## Technical Tip

**Model:** DTR-4.6/5.6/6.6/7.6

**Subject:** Remote and Wired remote does not respond well to input commands

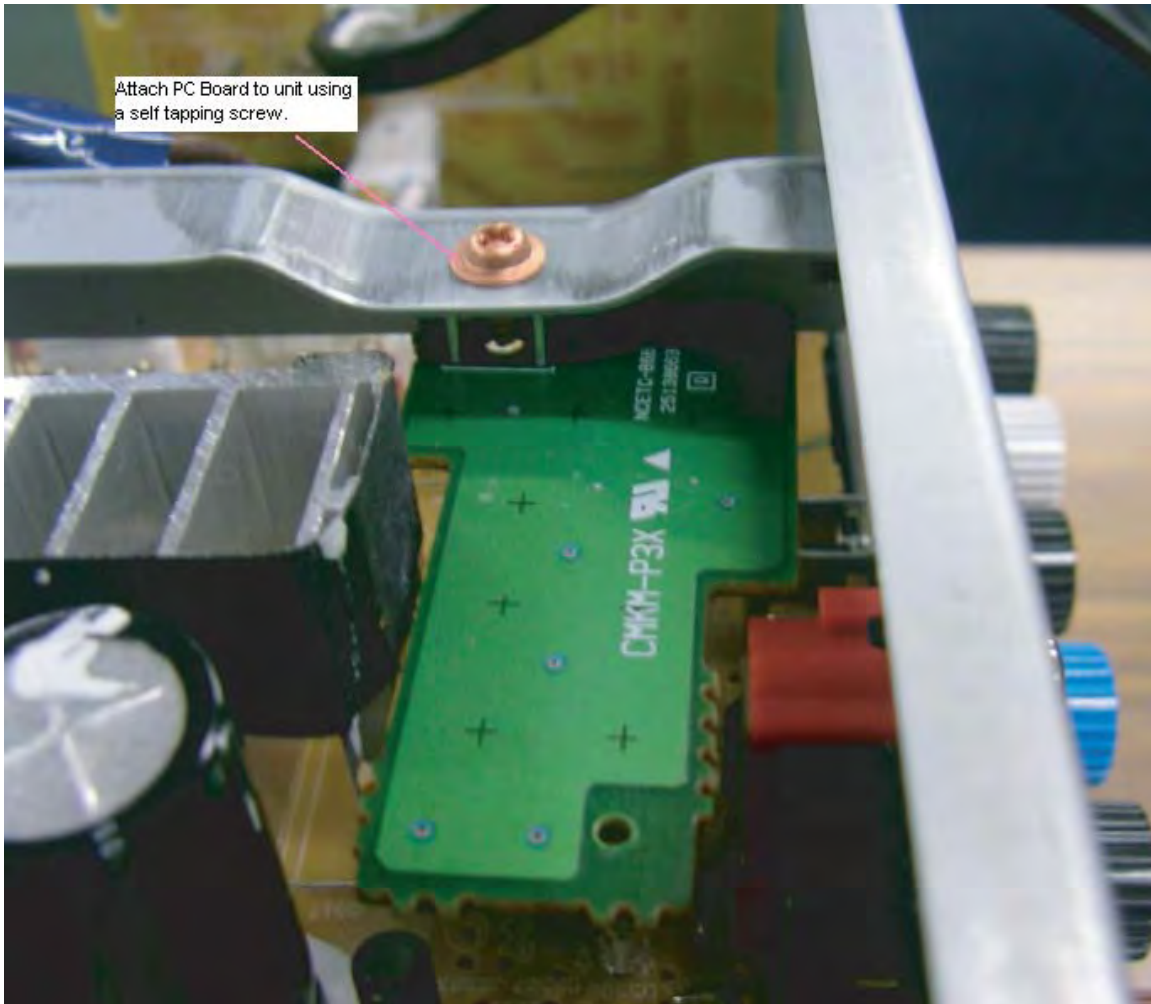
**Symptom:** When using remote or an external IR controller connected to the rear panel IR input the set may not respond properly to IR commands.

**Solution:** Install the IR Shield PC Board as described. Cover the IR Remote Sensor.

- 1.) Solder the Terminal Connector to the PC board.
- 2.) Attach the PCB you assembled to the set using a self tapping screw.

Attach PC Board to unit using a self tapping screw.
